37/3-92B 7207 Maple Avenue
Takoma Park Historic District

MEMORANDUM

SUBJECT: Historic Area Work Permit Application

HISTORIC PRESERVATION COMMISSION STAFF REPORT

Elevations

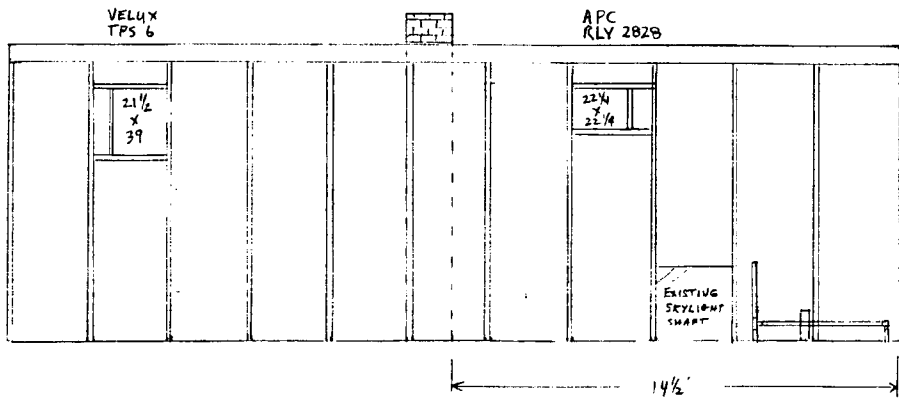
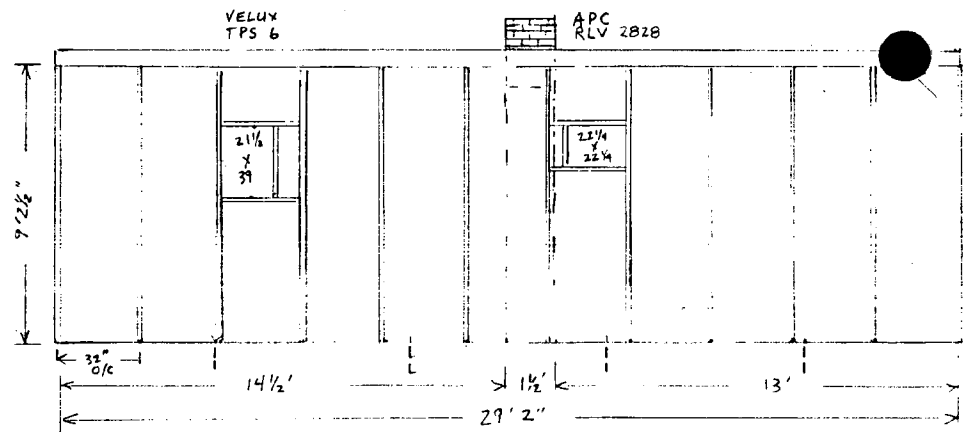
- 1) Two skylights, instead of 4, will be installed
- 2) The skylights will be installed toward the rear of the wood
- 3) wooden sash or casement windows will be used - either new or historical stock

The four skylights would be of one size, installed to align at their top edges. Measuring approximately 22" x 22", the skylights would be visible from the street. They are flat in profile, of clear glass, and would have anodized bronze-color flashings. Note that the proposal submitted by the applicant has been amended during the review period so that all the proposed skylights are of the smaller dimension.

The skylights would be entirely visible to public view. The staff recommends that the Commission find the use of skylights in the proposed locations acceptable in this case, however. Flat skylights, when appropriately placed, are considered generally acceptable under the design guidelines adopted during inclusion of the Takoma Park Historic District on the Master Plan for Historic Preservation.

The staff interprets "areas that do not directly front on a public right-of-way" to mean that side gable faces (as opposed to front gable faces) are acceptable locations for skylights.

West Wall

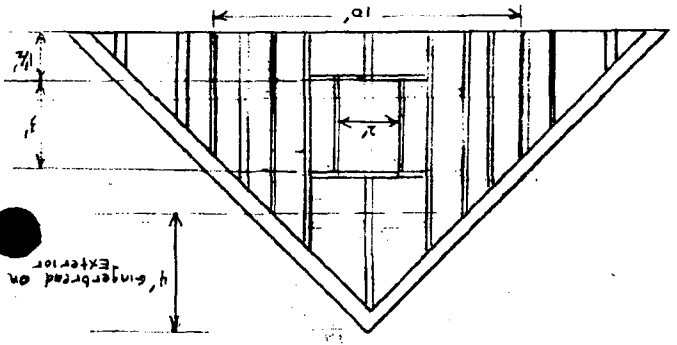
The sash windows (with true divided lights) would be built in the gable ends, one of which faces the street, where no openings currently exist. The front gable end is a prominent feature of the house due to its vertical height and scale and its shingled surface. The windows would measure 24" x 36".

The staff also recommends that the proposed sash windows be found consistent with the design guidelines, since they are compatible with the style of the house. Many Queen Anne-style houses have similar gable end windows. As the design guidelines for category 2 resources state:
